CITY OF CHARLEVOIX
210 STATE ST. CHARLEVOIX, MICH. 49720
PLANNING COMMISSION PUBLIC MEETING AGENDA

SUBJECT: Site Plan review: Irish Boat Shop CYC, 220 Ferry Avenue

AGENDA TITLE:		<u>Level B Site Plan Review 2019-01 SP: CYC</u>
PUBLIC MEETING DATE:		February 11, 2019 6:00PM
EXHIBITS:	1. Site Plan Review application. 2. Site Plan provided by applicant. 3. Department Head statements 4. City of Charlevoix Zoning Ordinance.

SITE PLAN
SCALE: 1" = 20'-0"

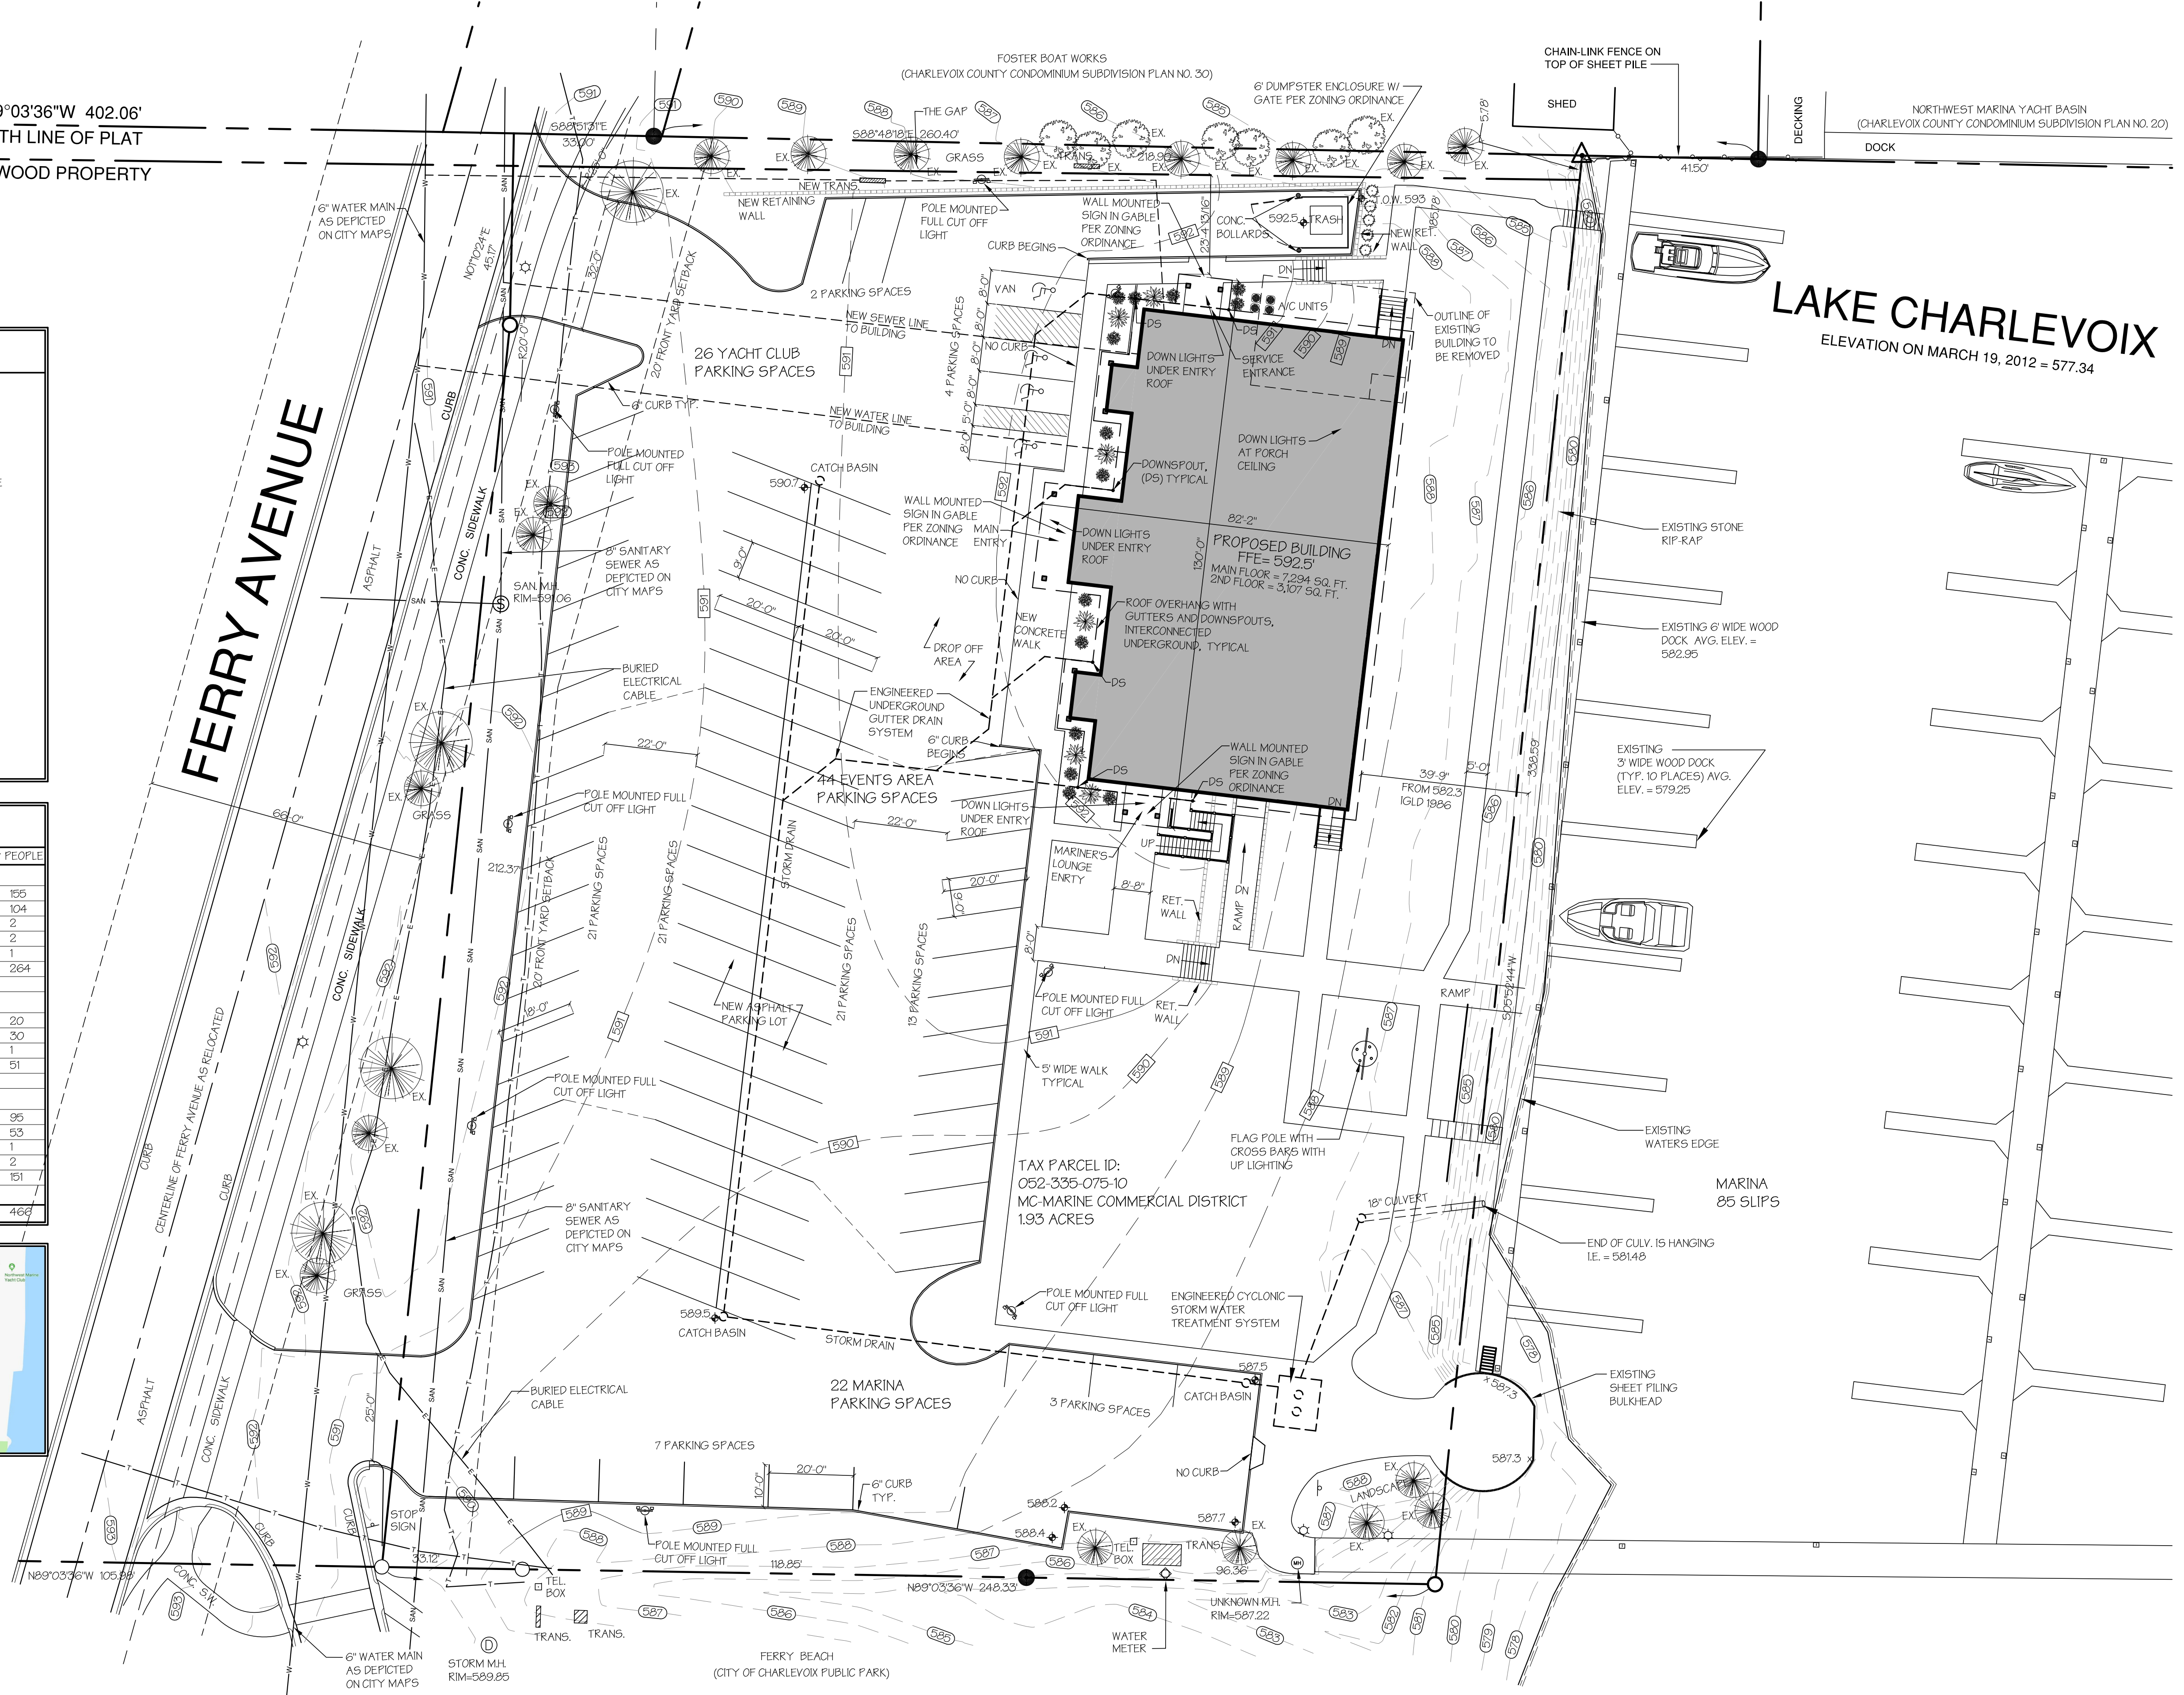
The proposed development shows three types of parking patterns. The proposal shows 78- 9 foot by 20 foot angled parking and 10- 10 foot by 20 foot parallel spaces respectively. There is also 4 pull in handicapped spaces. All aisles are 22 foot or wider. The Planning Commission finds that the proposed development meets this requirement.

The proposed development includes new dense planting areas to the north of the parking area adjacent to the residential condominiums and to the east facing the lake. To the west along Ferry Avenue there is a proposed berm with turf grass. Most existing mature trees are to stay. The proposed landscape plantings meet or exceed the minimum requirements of the ordinance. The Planning Commission finds that the development meets these requirements.

There are no proposed parking islands. The applicant is asking to relax these standards as the other usage of the parking lot is, and has been winter boat storage. The Planning Commission finds that by not requiring the parking lot islands, there will be no ill effect on this development, surrounding properties or the general public.

The Planning Commission finds that the proposal includes a screened dumpster. No other screening will be necessary. The Planning Commission finds that existing mature vegetation and additional planting's will be sufficient on the north side to screen the

The rendering indicates a retaining wall would be installed as well as new plantings on this same north perimeter of the CYC property. We would propose that a 6-8' fence be installed that would better contain noise, blowing trash, foot traffic, and general operating activity within the CYC property location. It would also provide a more visually attractive view of the CYC property from the north.

The existing condominiums at Foster Boat works provide a quiet and serene setting, and have been established on this site for many years. Placement of a structure of this size only ten feet from the common property line will likely disturb the peace and tranquility at Foster Boat Works. All Foster Boat works units have either a patio or deck facing the water, and cooperative steps have been implemented both at Foster and at Northwest Marine Yacht Club for quiet hours after 9:00 P.M. The anticipated usage of the proposed structure will make enforcement of "quiet hours" nearly impossible to accomplish. The proposed use will surely have numerous activities well beyond 9:00 P.M. Given the addition of balconies and patios in the proposed structure, and the fact that noise travels easily over water, we foresee significant noise issues if the proposed use is authorized as submitted.

Landscape Plan

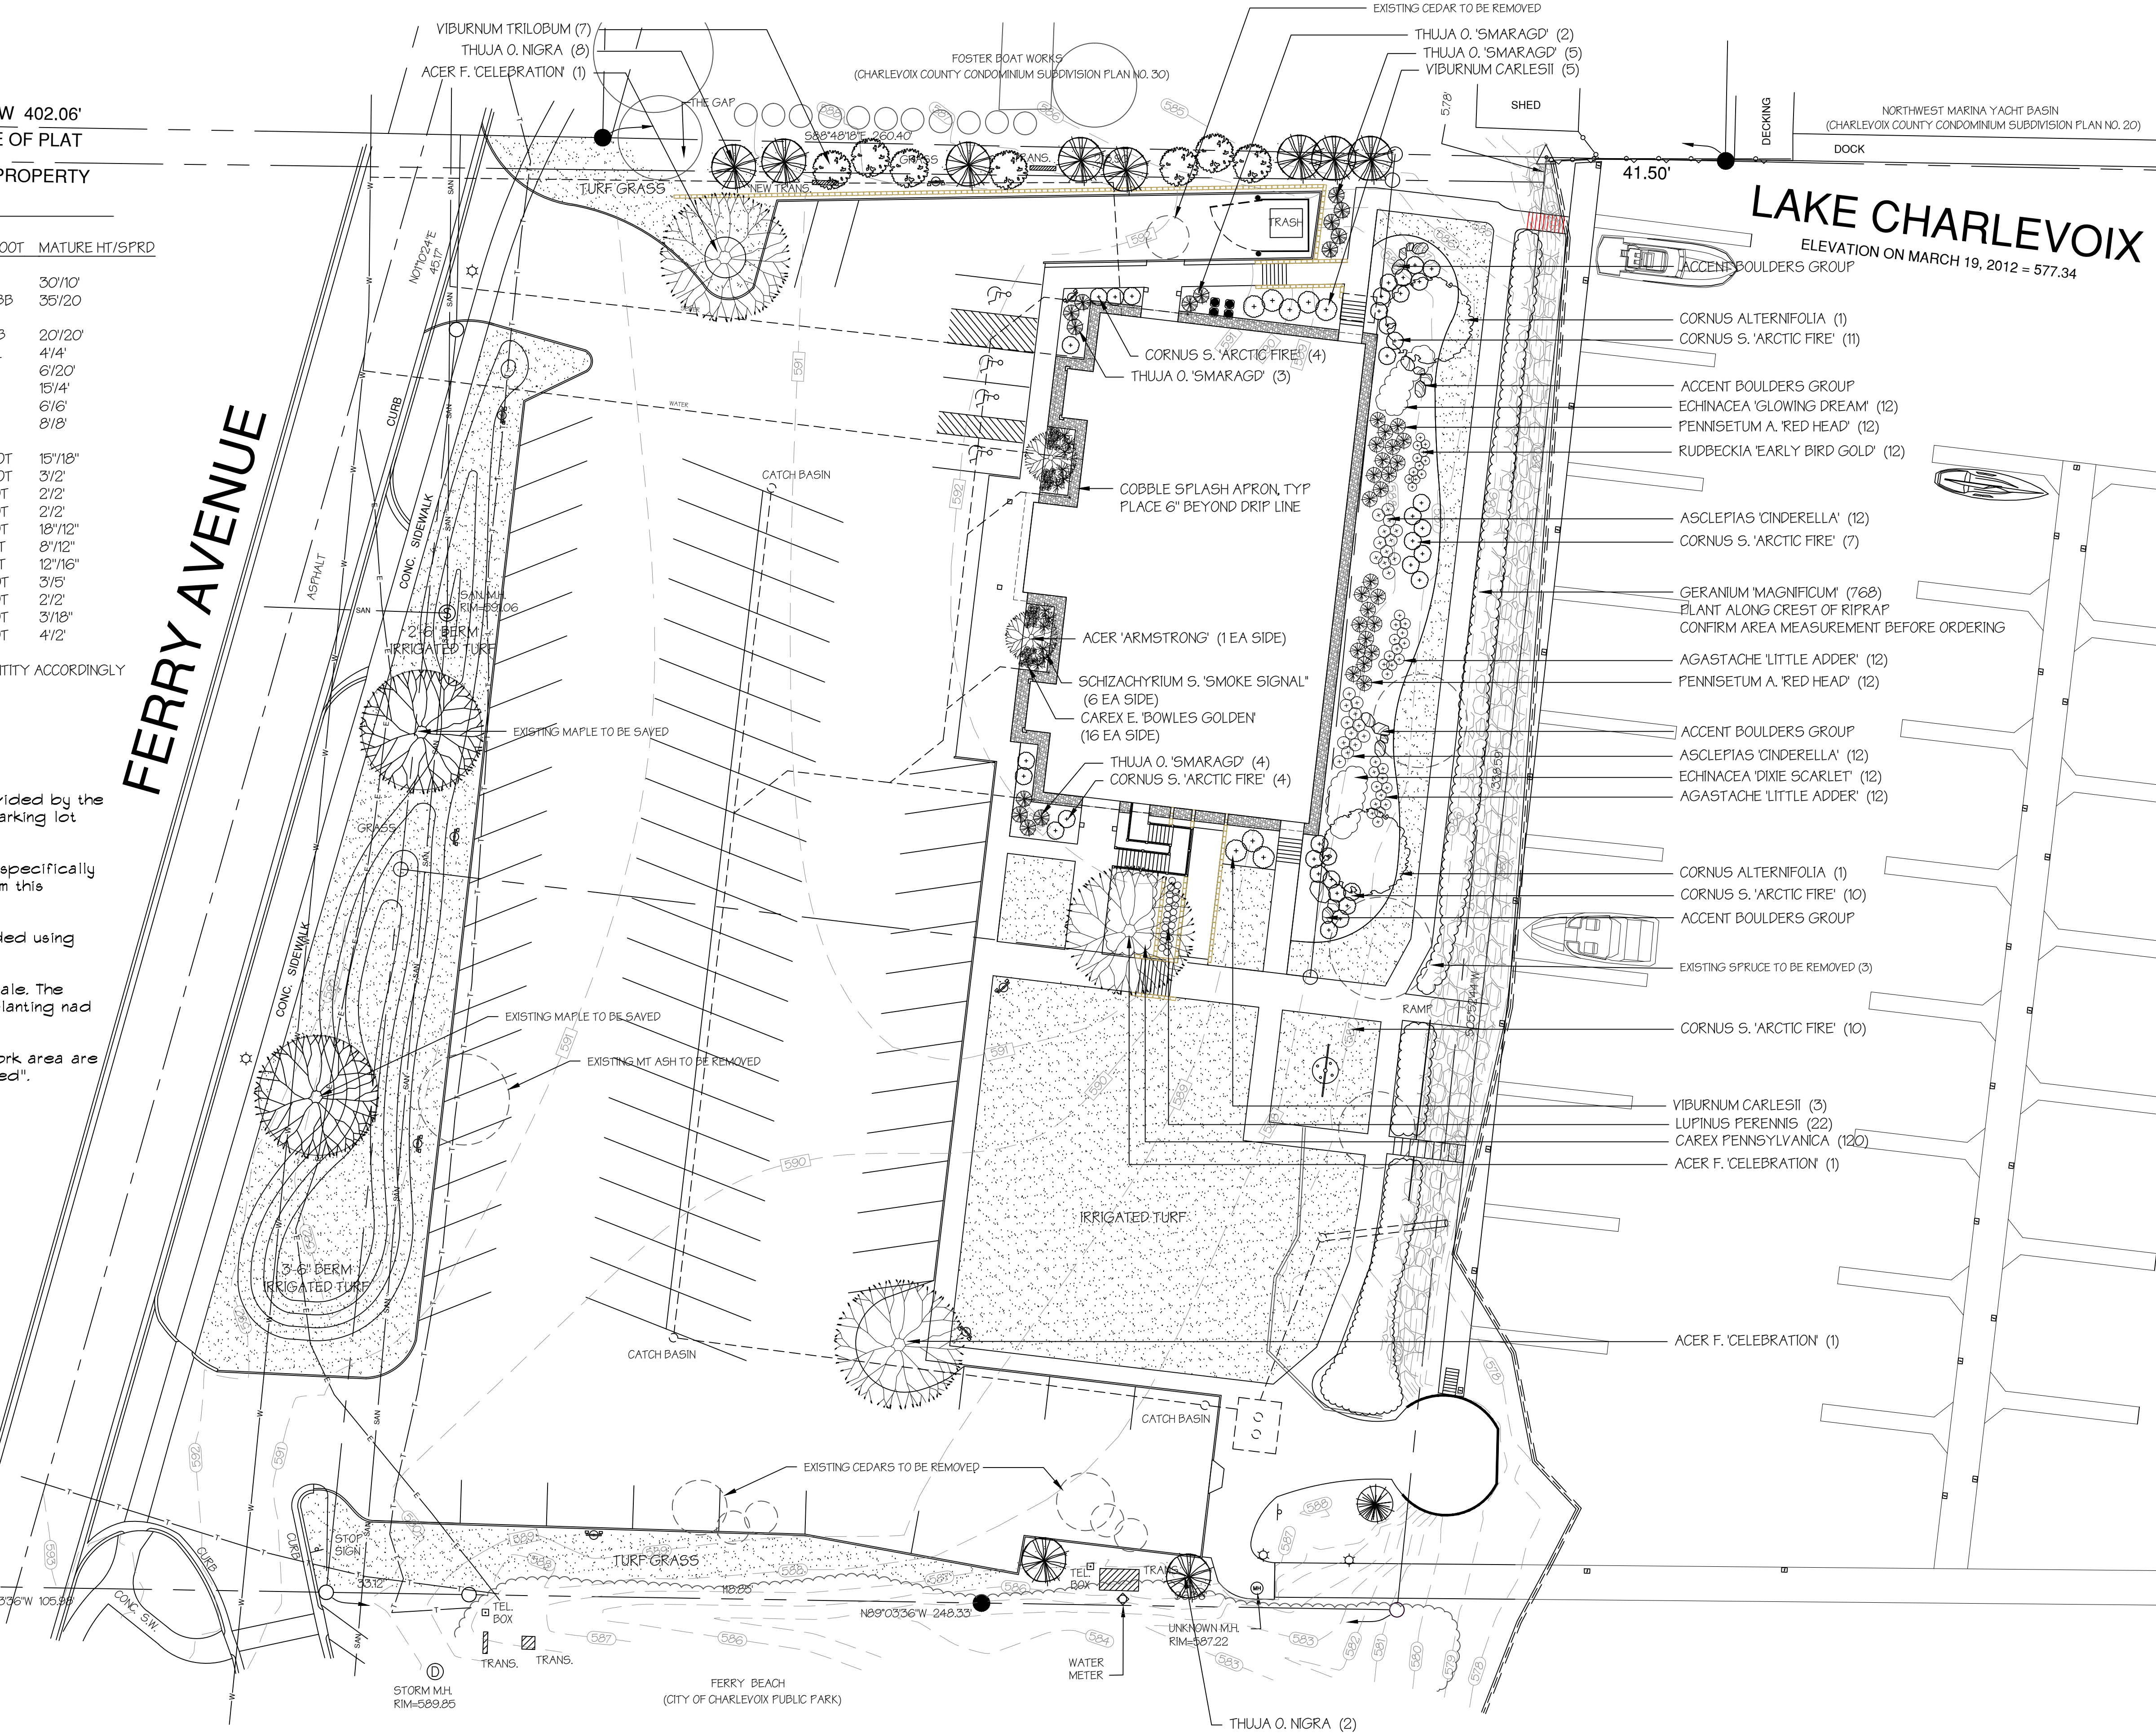
The applicant has proposed keeping two existing mature Maple trees but not adding any additional trees or shrubbery on the west side of the property adjacent to Ferry Avenue as any additional trees may block views of the residential condominiums to the west of the proposed development when full grown. The Planning Commission finds that the proposed landscape plantings meet or exceed the rest of the minimum requirements of the ordinance.
